Market Information ABS relay valves with adapter cable in a set

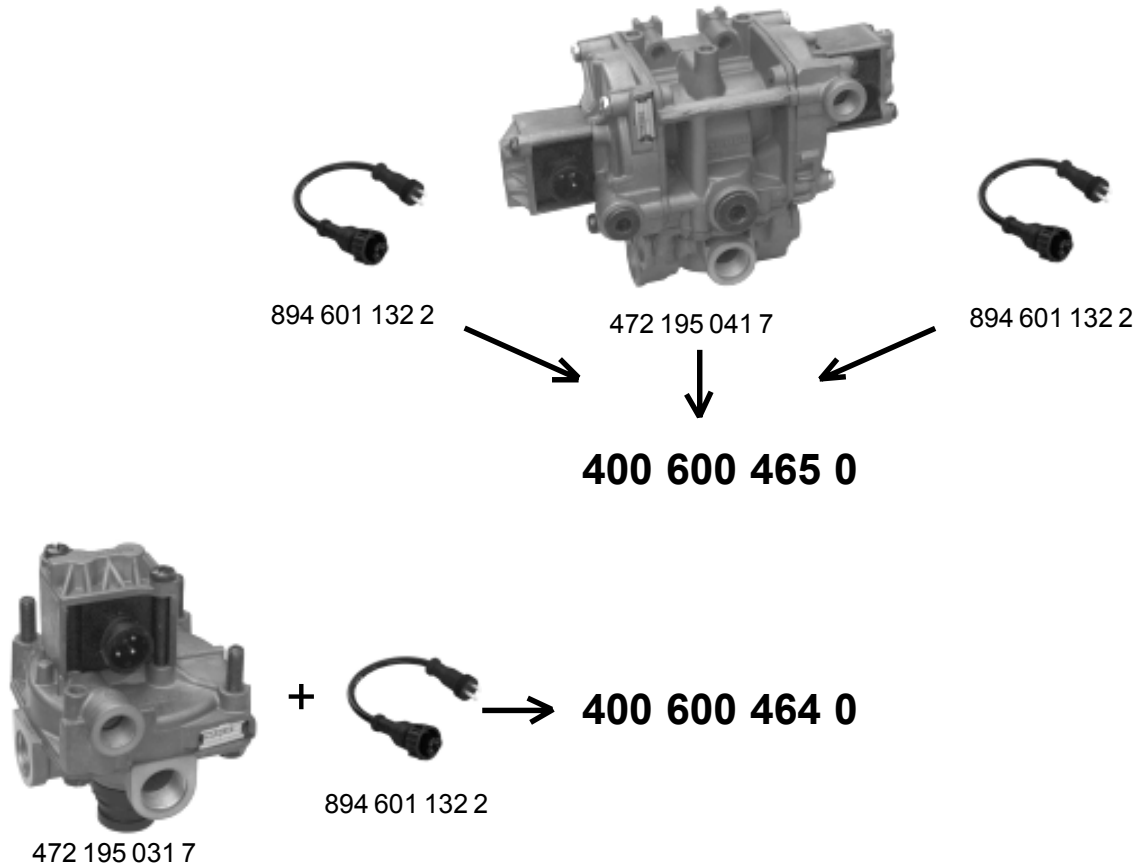
As we announced some time ago, WABCO will in future be selling ABS relay valves with DIN bayonet locks instead of the old Costal connection.

It will take some time for the changeover to reach all the vehicles on the market, And new trailer vehicles are already being equipped exclusively with DIN bayonet cables and units. When you are replacing defective ABS relay valves, we recommend that you also change over the cables, Otherwise you will need an adapter cable which you can obtain from your WABCO partner by quoting order number 894 601 132 2.

For a transitional period, we are going to be offering two important replacement variants for the replacement market in one set together with the adapter cable:

472 195 020 7 replaced by **400 600 464 0** (472 195 031 7 + 894 601 132 2)

472 195 040 7* replaced by **400 600 465 0** (472 195 041 7 + 2 x 894 601 132 2)
